Addendum #2 - Bid Package #6929-06

Project Name: Lincoln Public Schools District Office
5901 'O' Street
Lincoln, NE
Project No.: 11065
Issued: June 19, 2012

Sketch A1
 Bid Package 6929-06
 Addendum 02

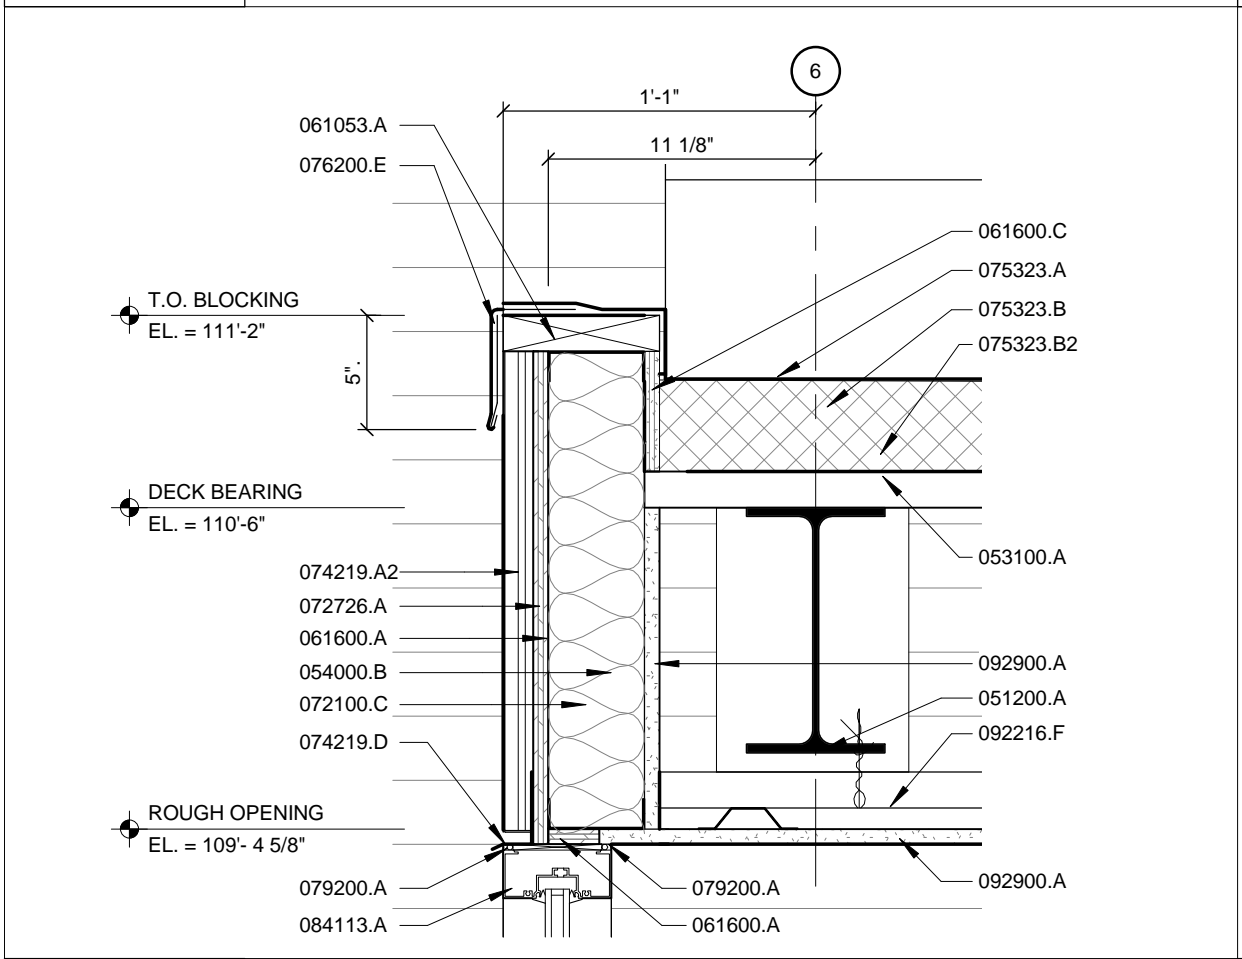
ADD 2-18. Refer to Sheet A400, Detail K4; Part of the detail was omitted from the issued print. Refer to attached **Sketch A1** for the entire detail.
